## Product Change Notification

**1. ECR #:** 156683  
**Notification #:** 291

- IDMD - INSULATION DISPLACEMENT TERMINAL CABLE
- IDMS - INSULATION DISPLACEMENT TERMINAL CABLE

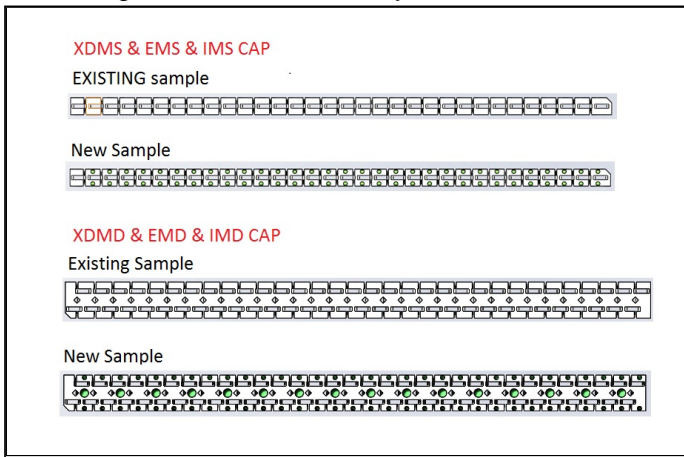
Round voids were added to the cap top surface. Customers may receive either/both existing and new revision material until the existing material is depleted.

The changes can be identified by the round voids on the cap top surface.
